COAL MINING AND RECLAMATION PERMIT APPLICATION TO REVISE A PERMIT (ARP)

Permit Number: D-1159
Application Number: R-1159-7

APPLICATION TO REVISE A COAL MINING PERMIT

This revision is to show the approximate as-built location of the coal refuse placed in the #12 Pit on the east side of the overland conveyor.

SPOIL, FILL & COAL WASTE PROFILE H-H'

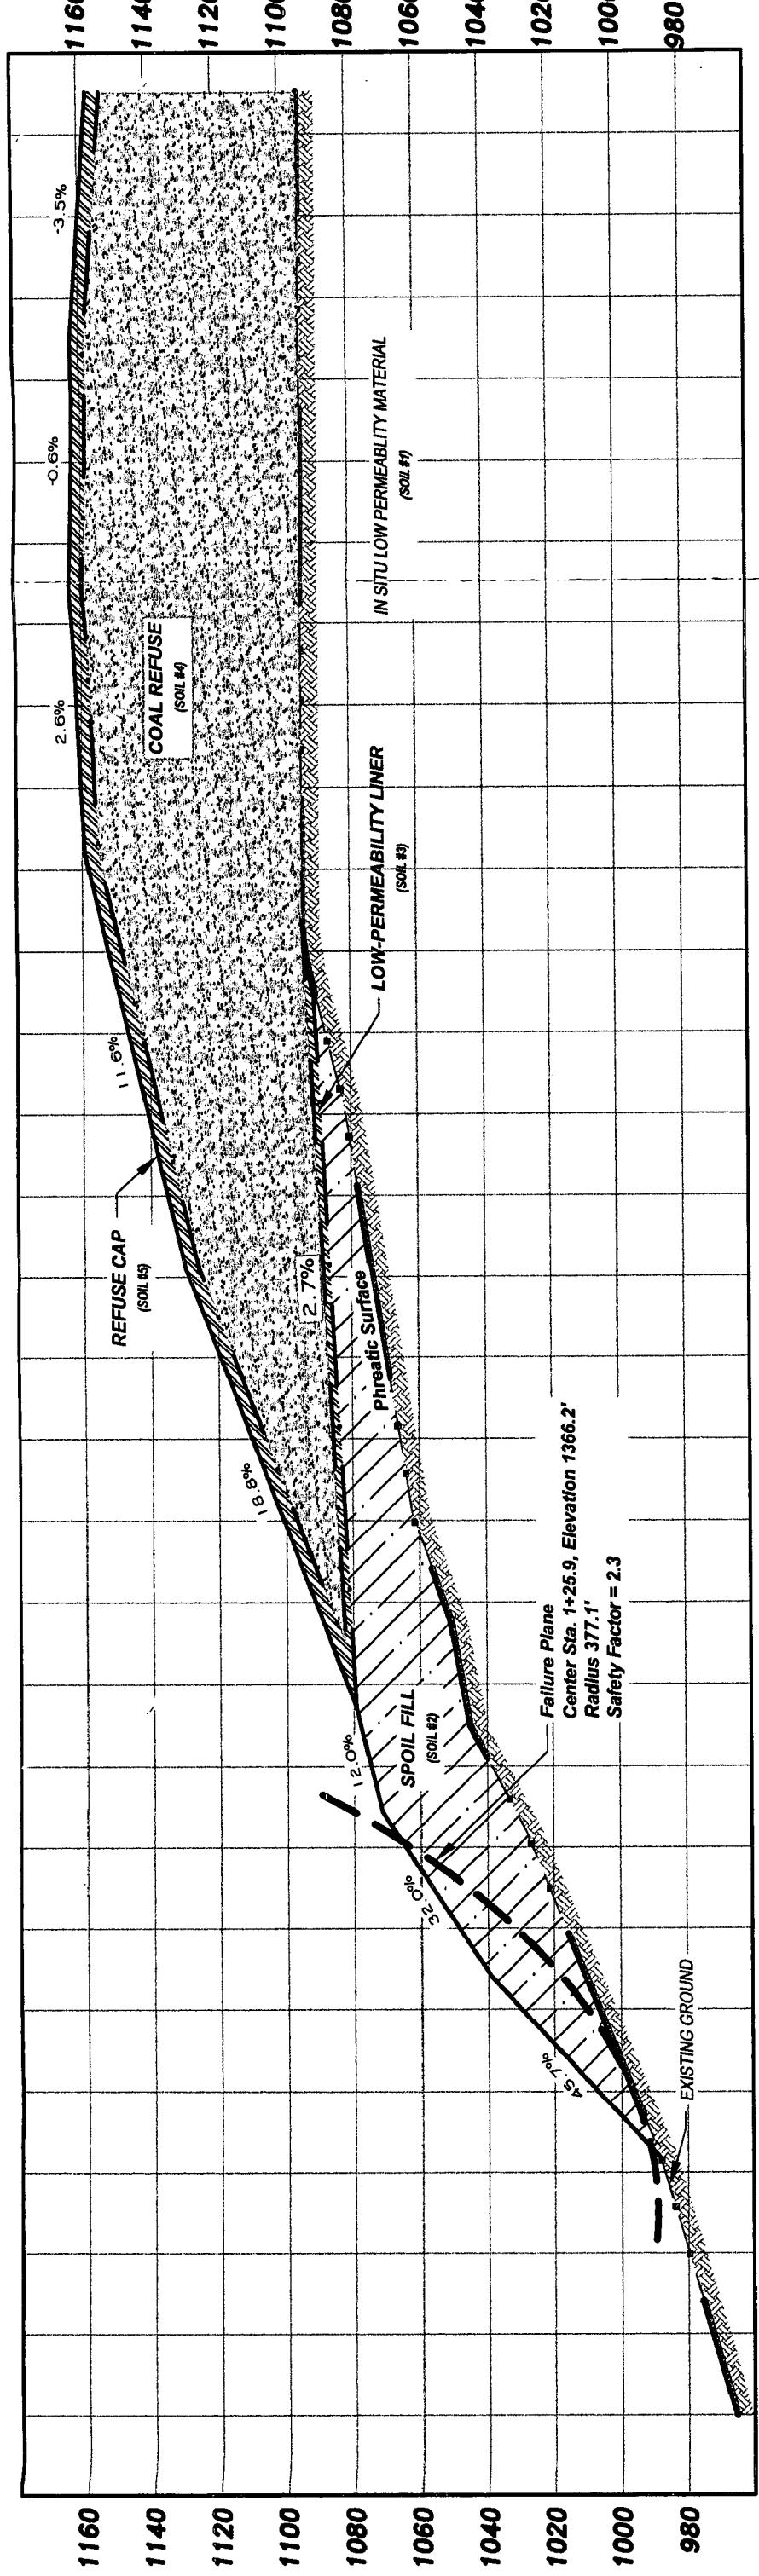
THE MINIMUM FACTOR OF SAFETY IS 2.329

FACTOR OF SAFETY BY SIMPLIFIED BISHOP METHOD IS 2.329

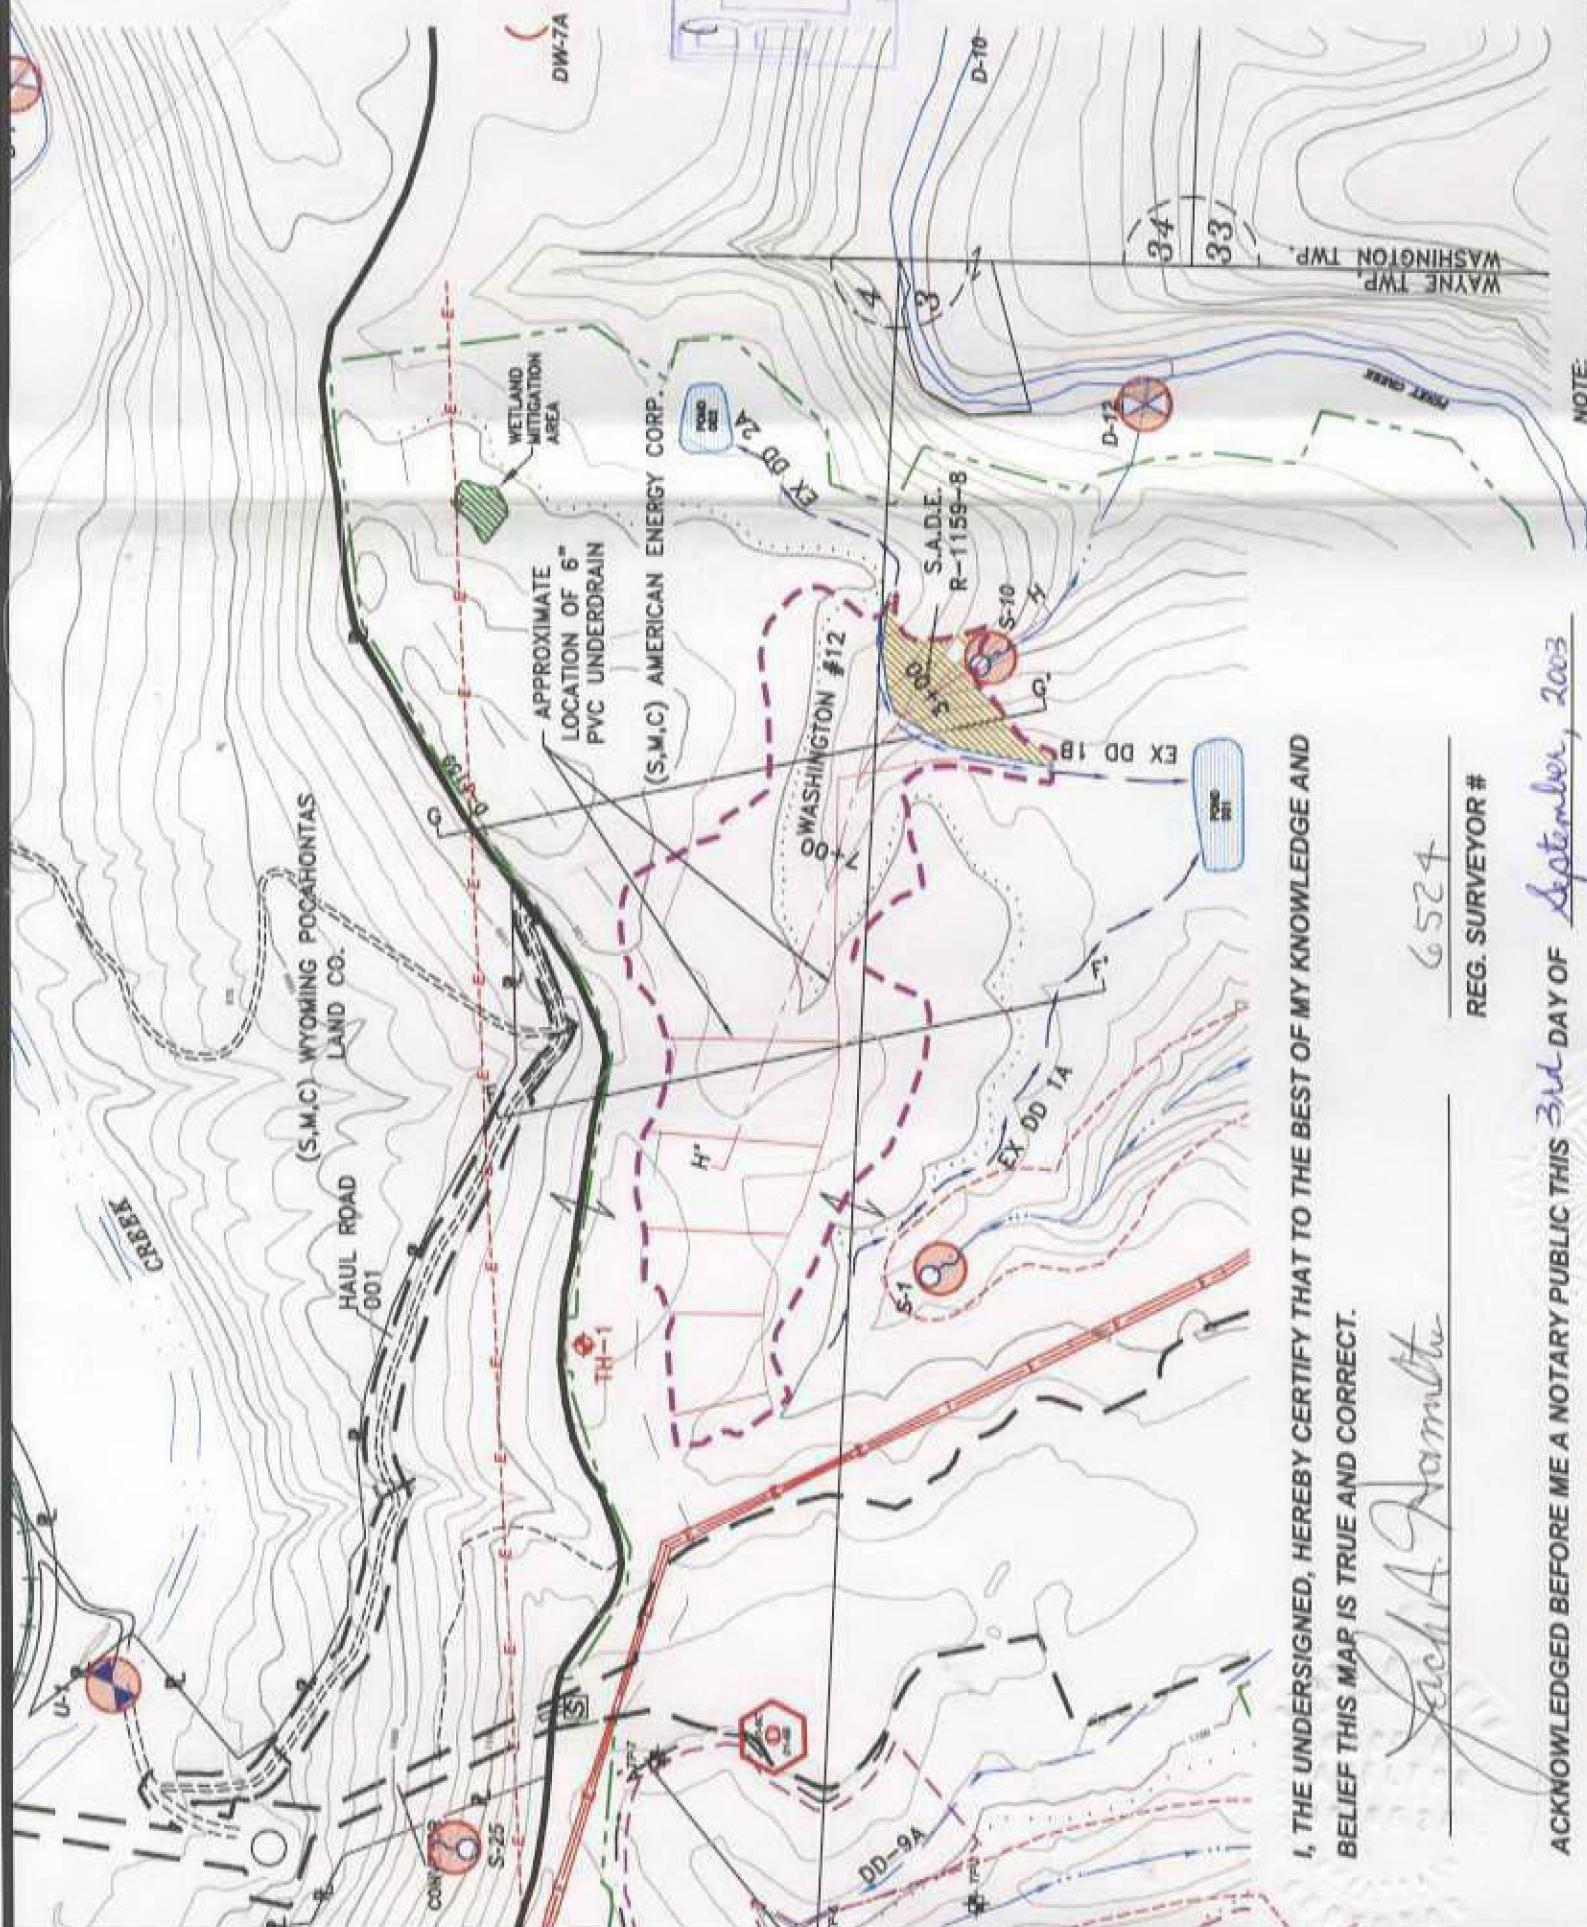
To show the actual as built location of the coal refuse disposal in the #12 pit and to abate N.O.V. 24363.

NOTE:
APPROXIMATE LOCATION AND CONFIGURATION OF
COAL WASTE IS BASED ON FIELD SURVEY AND
VERBAL STATEMENTS PROVIDED BY BENNOC, INC.
FIELD REPRESENTATIVES.
